WATER PERMIT NO. 8858-3

Name of Applicant: **Plainview Dairy, LLC**

SOUTH DAKOTA
WATER PERMIT NO. 8858-3

Application for Permit to Appropriate Water in South Dakota

SITE PLAN

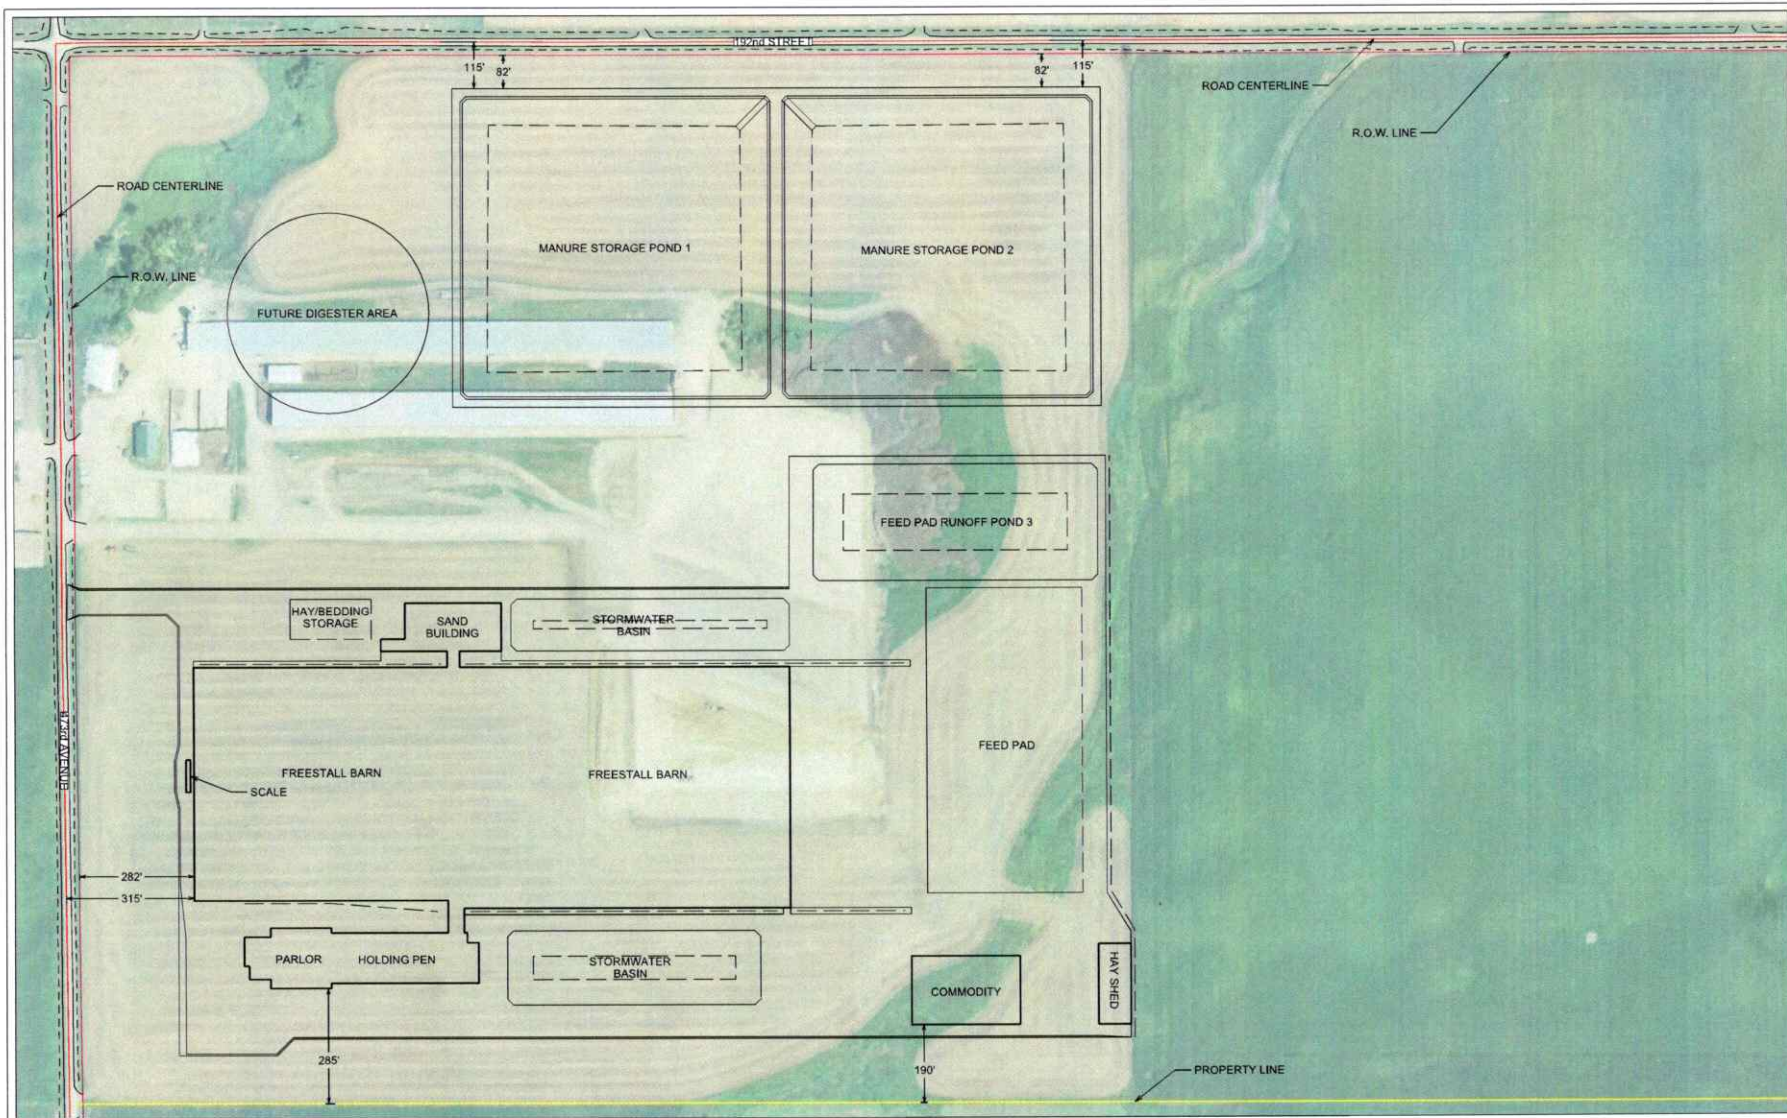
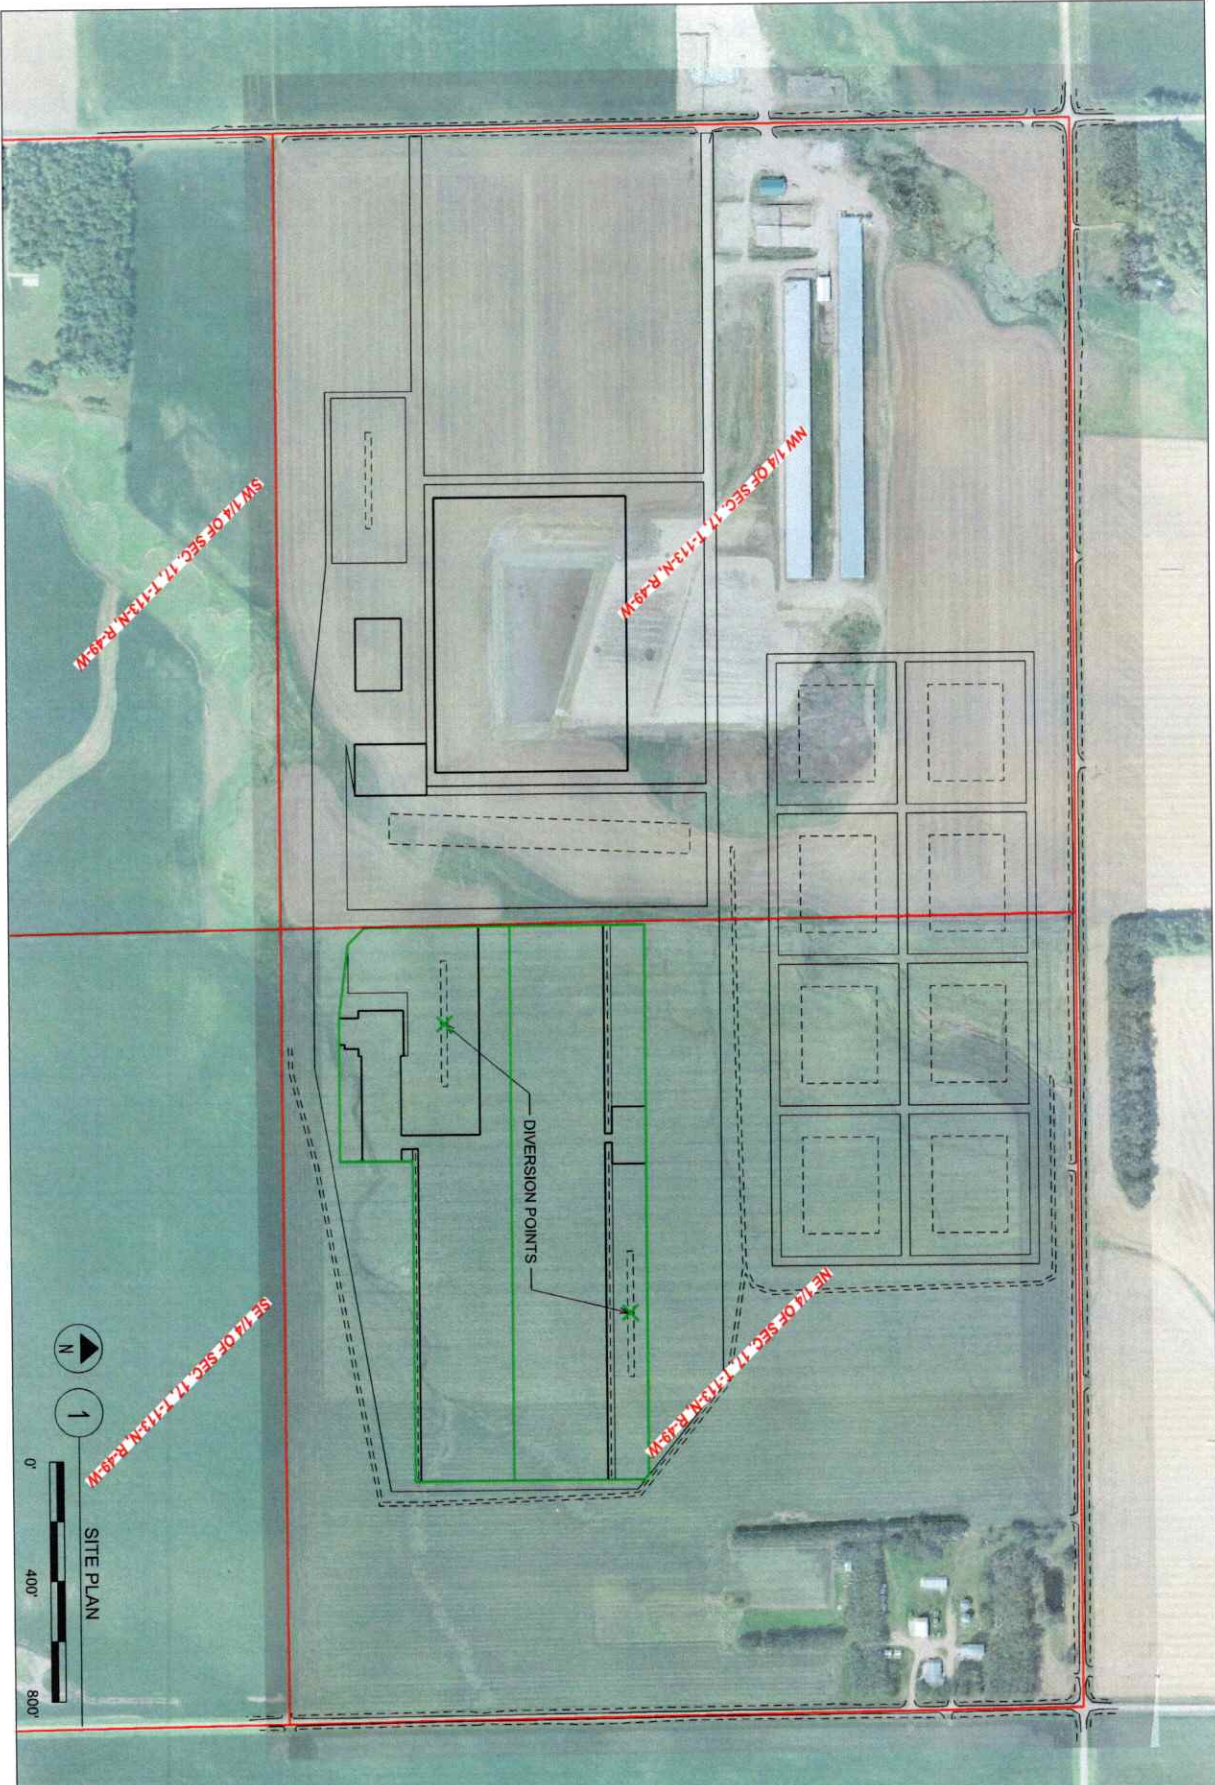
As for the map, the "X" should be placed on the location of the storage retention basin.

As for the map, the "X" should be placed on the location of the storage retention basin.

I do have another question. The application makes reference to a stormwater retention basin and to two dugouts. It is not clear to me whether the dugouts are the same as the stormwater basin or, if the dugouts will exist along with the stormwater basin. A basic layout map was submitted by Settje with the application and on that map two diversion points were labeled marked with an "X" and called "Diversion Points." I have added a green "X" in the approximate locations provided by Settje on another layout plan which included the stormwater basin labeled (I highlighted it in yellow – see attached). Please indicate whether there are dugouts in addition to the retention pond or if we are just using different terms for the same structure(s). Also, on April 18, Eric Gronlund requested dimensions and storage capacity of the storage features (stormwater basin/dugouts), we were provided dimensions for dugouts it appears, but we don't have storage capacities. In addition, please provide a description of how water will be routed through these structures so we have an understanding of how captured runoff moves from storage to the dairy separator facility.

- The owners are looking to capture and use the roof runoff water from the freestall barn and some water from the surrounding drive surfaces. That water will be stored in two dugouts adjacent to the barn (the two green X's that you have shown and that we marked on the plan – reattached to this email). Those dugouts are each referred to as stormwater basins – for the sake of this application we can call the north X the north stormwater basin and the south X the south stormwater basin. They will be constructed like dugouts as they will be dug into the surrounding terrain and therefore, they are not like a dammed storage structure with a berm.

- As you mentioned, there is also a larger looking dammed stormwater basin to the west of the barn, but at this time, the owners are not planning to use any of the water collected there. Instead, water from the upstream drainage area will be routed through that west stormwater basin and then out of the site to the south.

Please see the attached updated site plan. The surface area and amounts are the same as what was requested, but we have moved the entire site west as a result of discussions with the County and Township.

Figure 1: Map of the approximate basin/dugout locations and the roof runoff intends to be captured from

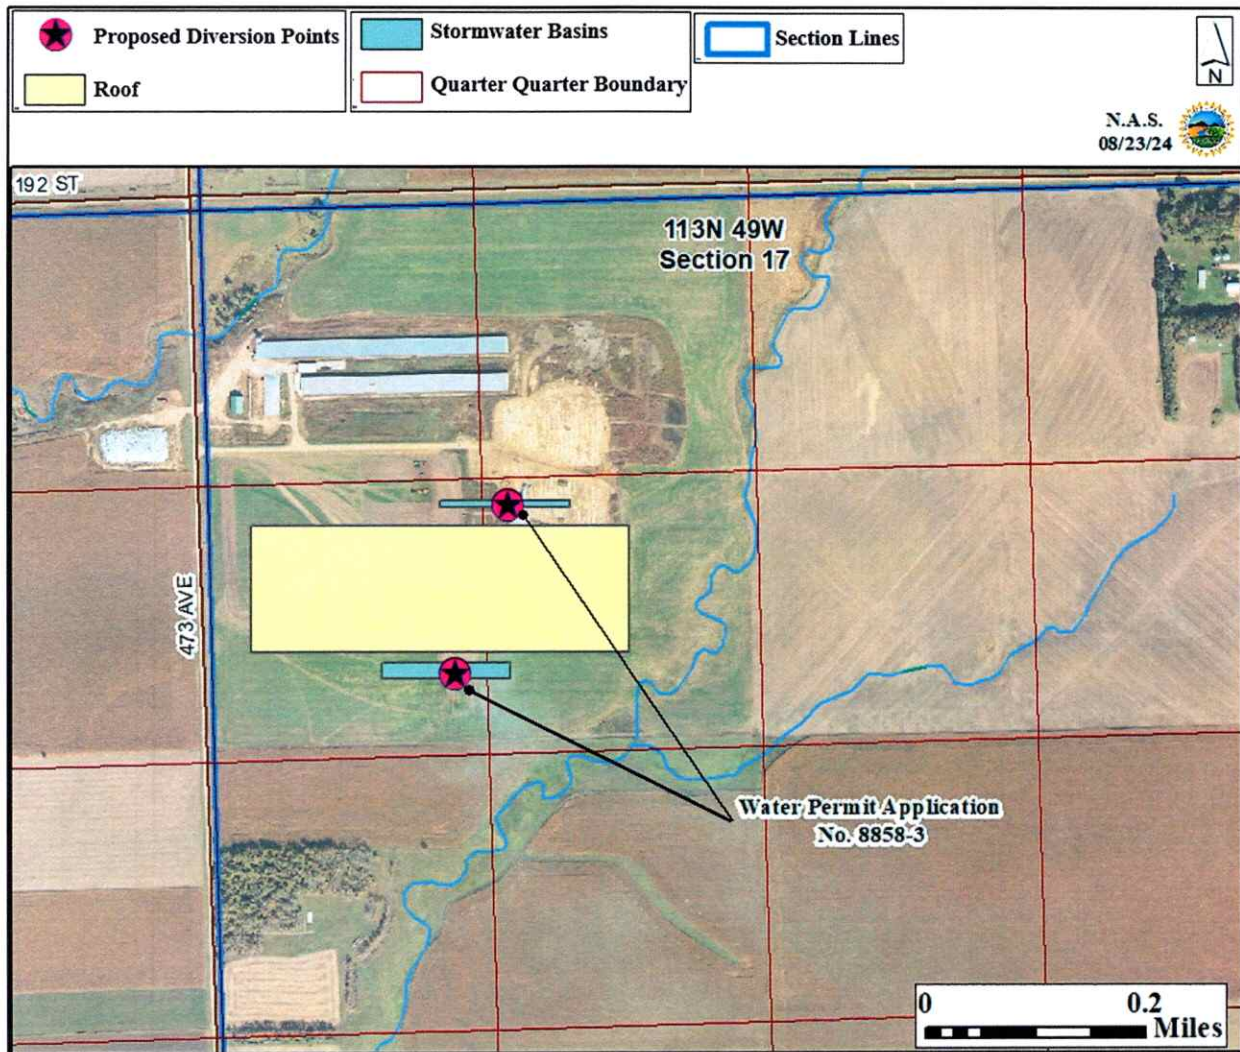
- Am I correct in assuming the 15 acres for each stormwater basin is the approximate drainage area being captured?
- The application is for 0.13 cubic feet of water per second and an annual volume of 91.78 acre-feet. Just by way of observation and to confirm this is what you intended, an annual volume of 91.78 acre-feet represents near continuous pumping at the applied for pump rate.

- Correct – this is the design/approximated drainage area for each stormwater basin.
- We figured what we might expect to see collected in those stormwater basins annually, and then we figured what that might look like pumping water into the separation system constantly for a conservative estimate. However in reality, we won't quite be pumping stormwater constantly into the system.
- The intent of the separator building is not to treat the captured stormwater, but rather to use the stormwater as a supplementary source of water to be used for the manure/sand separation system since the system requires water to operate.
